Reviewers' Comments:

In this report entitled 'Optoacoustic Brain Stimulation at Submillimetre Spatial Precision' Jiang et al. presents a series of experimental results demonstrating the use of optoacoustic effect for brain stimulation in a murine model. Authors report a new approach which allows superior spatial confinement of the US generated by the optoacoustic effect. Indeed, after the detailed description and characterization of their new device, authors present data on its use in neural culture, in vivo animal brain stimulation and modulation of motor activity with mapping cortical areas. It is concluded that the method can potentially be used for stimulating specific brain regions with unprecedented accuracy, with applications in research and therapy.

Figure S4. Illustration of a laser pulse train for 200 ms stimulation.

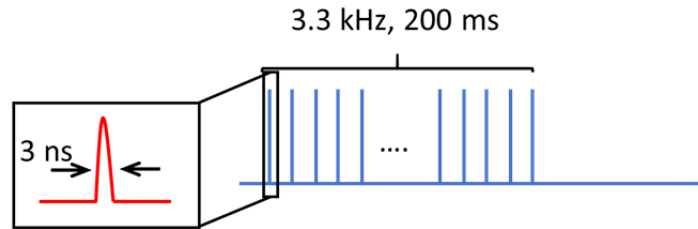
What does a 200 ms FOC stimulation pulse look like? Please add to Fig. 1. Was all the characterization done with the 3 ns pulse? Please characterize with the pulses used for stimulation. Laser pulses of 3 ns were repeated every .3 ms for a total of 200 ms. In the time domain, this is the pulse in 1b convolved with a comb function and multiplied by a rect function. In the frequency domain, this is the spectrum in 1b multiplied by a comb function and convolved with a sinc function. Please provide characterization plots for each stimulus used.

Re: Thanks for pointing out the confusion. Yes, the referee is correct. To clarify the 200 ms stimulation, we added a supplementary figure S2 showing the pulse train of light delivered to the fiber. All characterizations in Fig. 1 were done with a single 3 ns pulse.

Figure S2. Angular distribution of light intensity after diffusion layer.

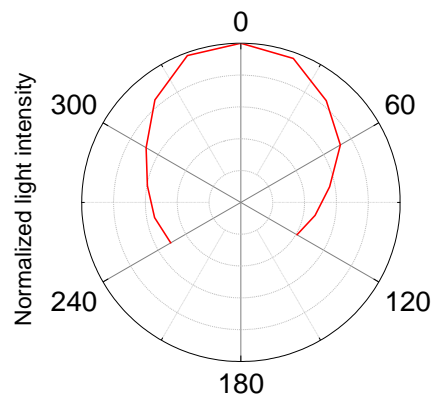
3. Line 84-85 + Fig. 1e authors should clarify the physical grounds for asymmetric US intensity distribution, given that earlier (line 76) the omnidirectional distribution of acoustic waves is mentioned.

Re: We appreciate the referee's comments. The omnidirectional distribution was achieved through the diffusion layer. The light intensity distribution after diffusion layer is shown below. Although light was collected at all angles measured, the forward propagating light ( $0^\circ$ ) intensity was higher compared to other directions, which yielded the ultrasound intensity distribution map in Fig. 1e. To clarify in the manuscript, we added supplementary figure 2 showing the light intensity angular distribution.

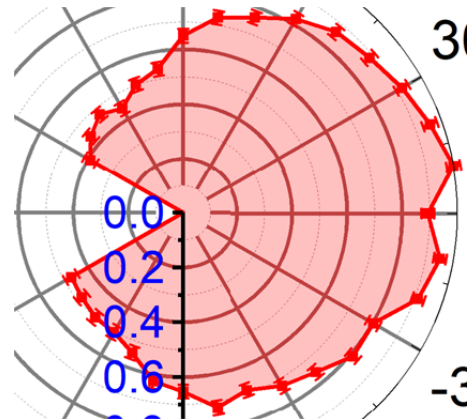
Also, Fig. 1 legend mentions standard deviation (SD) which is not shown. Finally, authors should improve the labeling of the graphs and provide the units where appropriate (e.g. graph d) and p values.

Re: We thank the referee for raising the concerns. The standard deviation in Figure 1e comes from 3 repeated measurements, which gives minimal variation, and small error bars were shown in the graph. Enlarged view shown below. We have updated the units in Fig. 1d and Fig. S1 and included p values where two-sample t-test was used.
